CODE CHANGE PROPOSALS FOR THE PROPOSED 2020 CONNECTICUT STATE BUILDING & FIRE SAFETY CODES

COMPILATION OF PUBLIC PROPOSALS

May 20, 2019

Figure 1. Components of a conventional fan system.

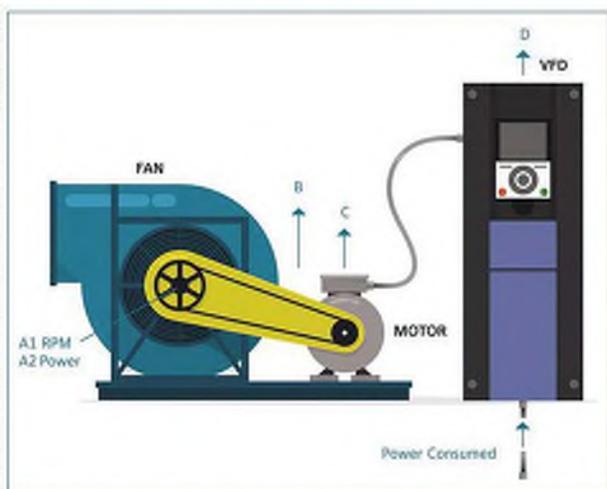
ANSI/AMCA Standard 207 covers most conventional fan systems, starting with the familiar fan total or static efficiency and fan-shaft input power based on fan airflow performance tested in accordance with ANSI/AMCA Standard 210, *Laboratory Methods of Testing Fans for*

Figure 2. What the air-systems industry thought it knew about motor losses with VFDs.

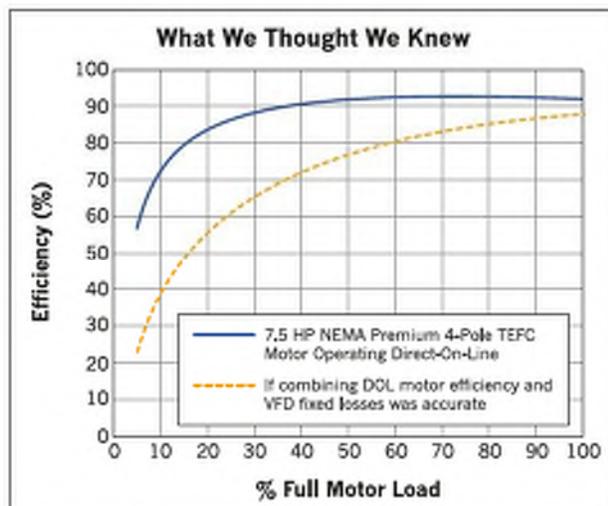
Historically, a significant problem for fan-system engineers was the lack of a standard method for calculating individual-component efficiencies, which made reliable comparisons of systems nearly impossible (Figure 2). The dilemma was exacerbated by the growing popularity of integrated electronically commutated fan/motor/controller packages, for which a manufacturer can certify only electrical input power, forcing designers to try to compare apples and oranges.

Figure 3. Comparison of a 7.5-HP four-pole TEFC motor operating DOL and one operating with a VFD per ANSI/AMCA Standard 207.

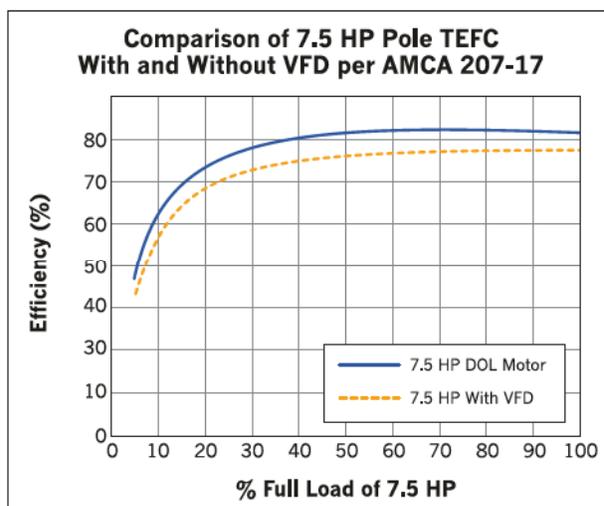
Figure 3 shows that the difference in efficiency between a motor operating DOL and one operating in conjunction with a VFD is relatively constant over the range of motor output power.

2013 ASHRAE Handbook—Fundamentals

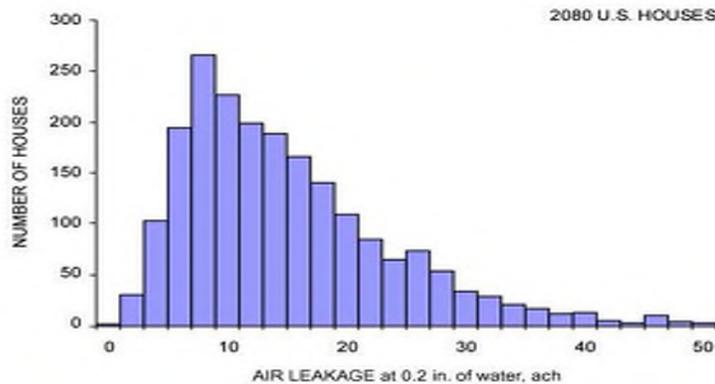
Building tightness is an important part of an energy-efficient and comfortable house. However, 3 air changes (ACH) per hour at 50 Pascals is an extremely low target tightness, especially for smaller homes. The ASHRAE Handbook of Fundamentals shows that around 8% of U.S. homes achieve 3 ACH or less, 13% achieve 4 and less than 23% achieve 5. The proposed 5 ACH while still an aggressive tightness level will provide a tight, comfortable, energy-efficient home.

2013 ASHRAE Handbook—Fundamentals

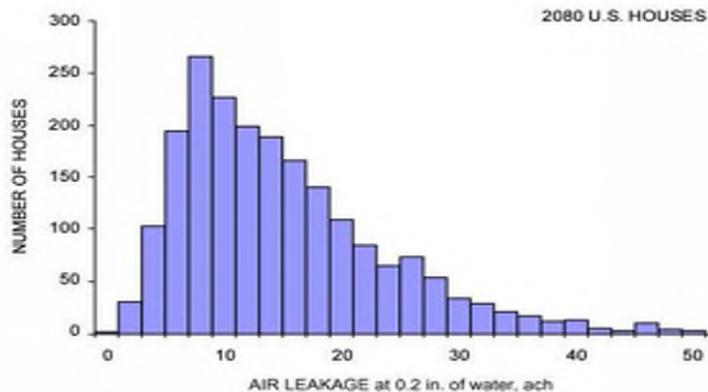
Building tightness is an important part of an energy-efficient and comfortable house. However, 3 air changes (ACH) per hour at 50 Pascals is an extremely low target tightness, especially for smaller homes. The ASHRAE Handbook of Fundamentals shows that around 8% of U.S. homes achieve 3 ACH or less, 13% achieve 4 and less than 23% achieve 5. The proposed 5 ACH while still an aggressive tightness level will provide a tight, comfortable, energy-efficient home.
